# CITY PLANNING COMMISSION

**APPLICATION:** Special Permit to construct a 2,118+ square foot Long John Silvers Restaurant with a drive-up service window.

**LOCATION:** Southeast corner of Northgate Boulevard and Winterhaven Avenue

EXHIBIT B  
 FLOOR PLANS

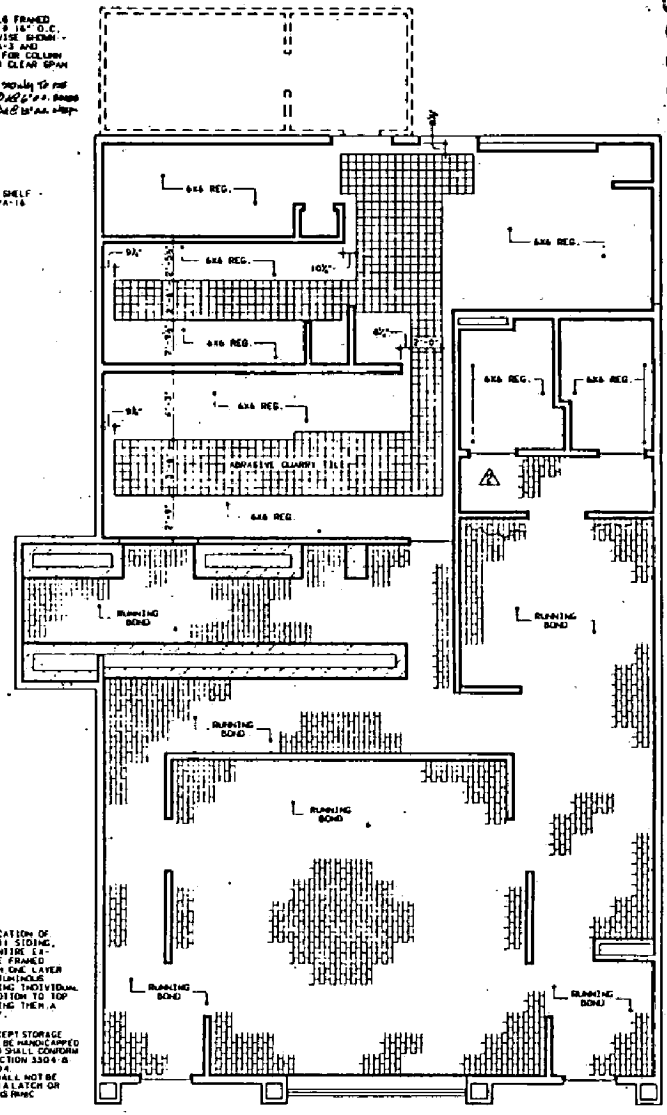
The applicant has depicted that trash enclosures for the restaurant will be provided within the trash enclosure area for the shopping center, which is located on the northern wall of the building. This trash enclosure area is in conformance with the standards for trash enclosures contained in the City Zoning Ordinance.

**EXHIBIT C**  
**ELEVATIONS**  
 P88-152

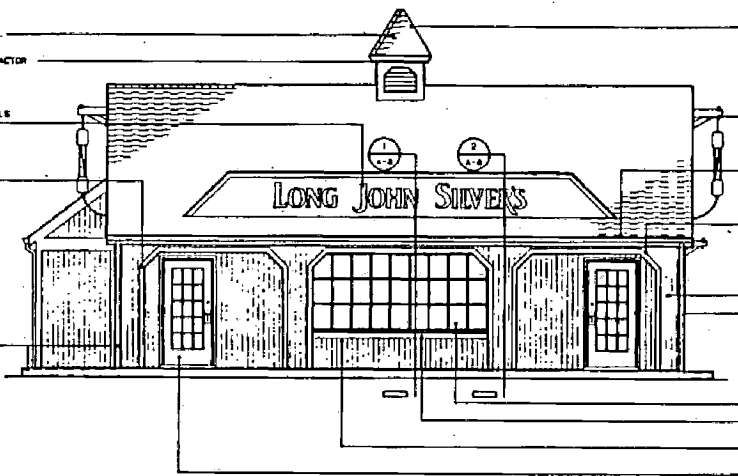
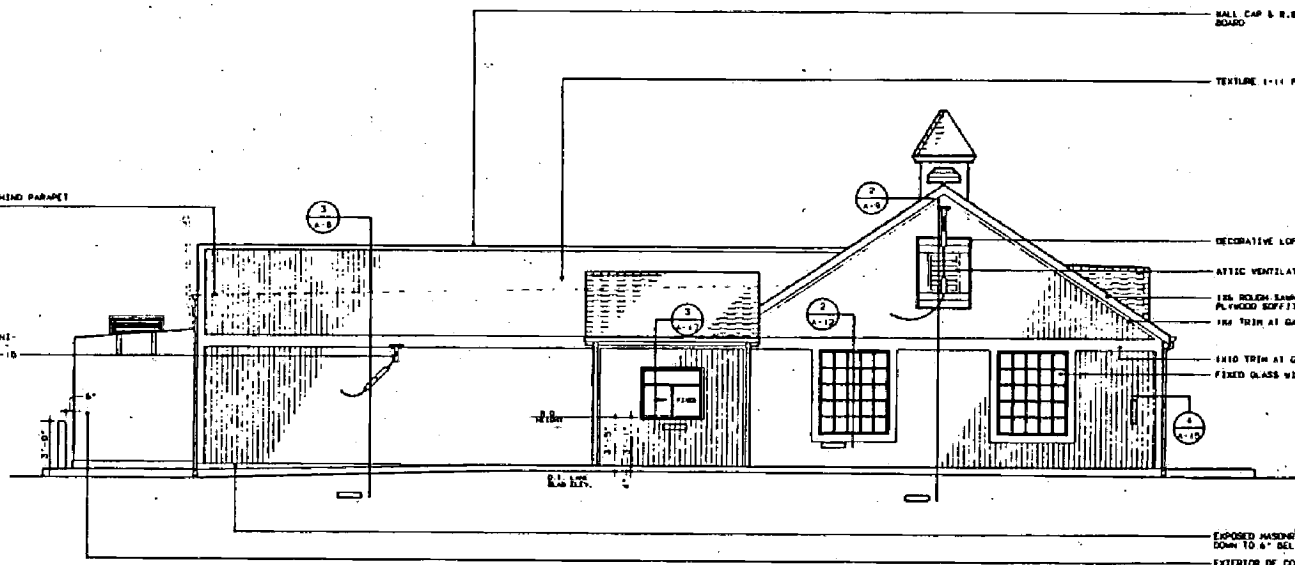
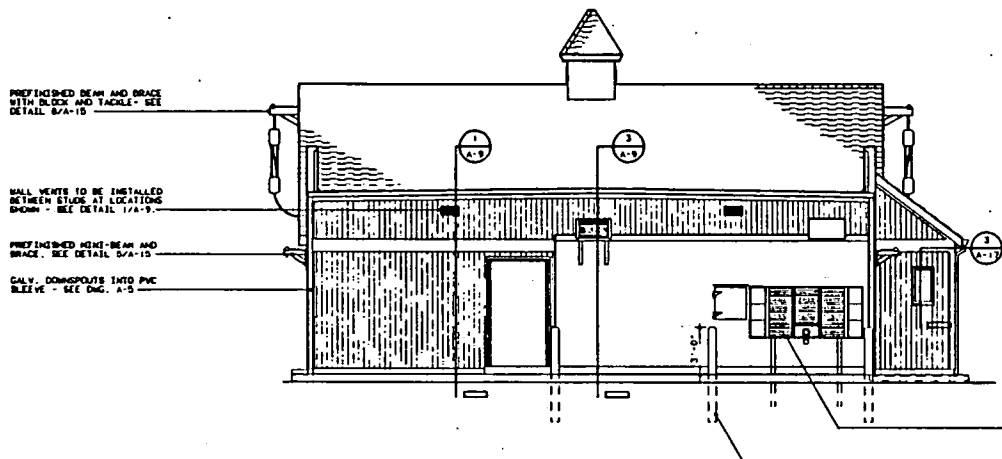
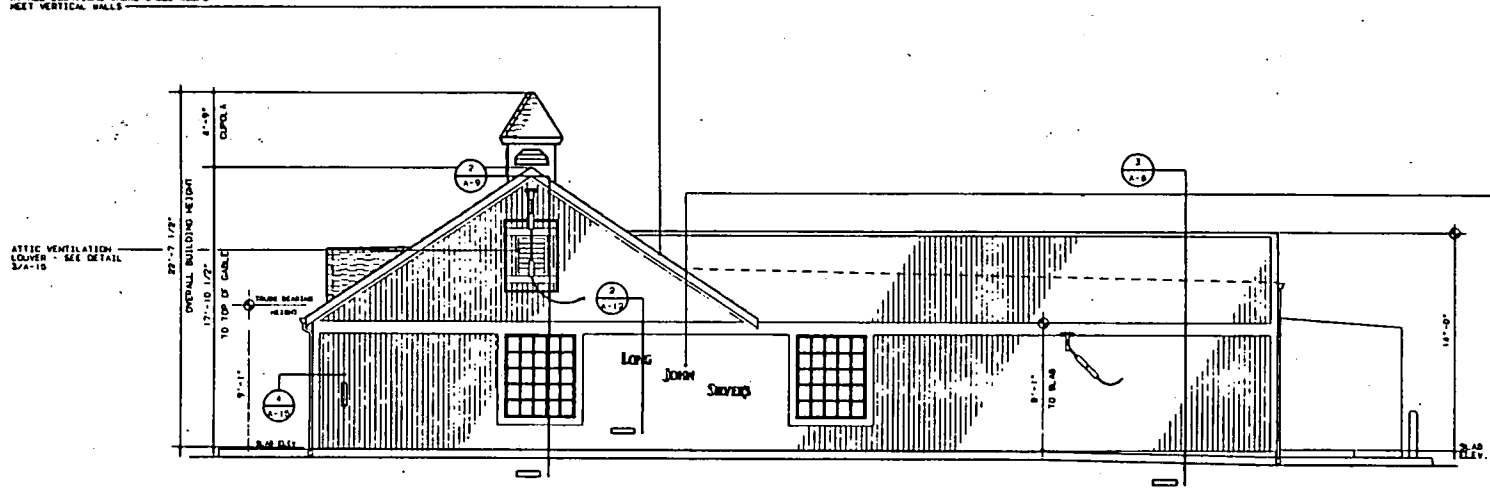
The Sign Ordinance permits one detached sign for each parcel at one square foot per lineal foot of frontage in the C-2 zone. Parcels with frontage on more than one street are permitted one sign for each street frontage. The shopping center has an existing monument sign fronting on Northgate Boulevard. The applicant could add their name to this sign. A detached sign is also permitted on Winterhaven Avenue. Staff recommends that this sign be a monument sign with a maximum height of 12 feet that shall be compatible with the existing monument sign on the site. The applicant has noted that they intend to install a pole sign, however, no sign elevations for a pole sign were included with the submitted site elevations.

The Sign Ordinance also permits two attached signs for each occupancy at three square feet per front foot of occupancy. The signs depicted on the submitted elevations are in compliance with the requirements.
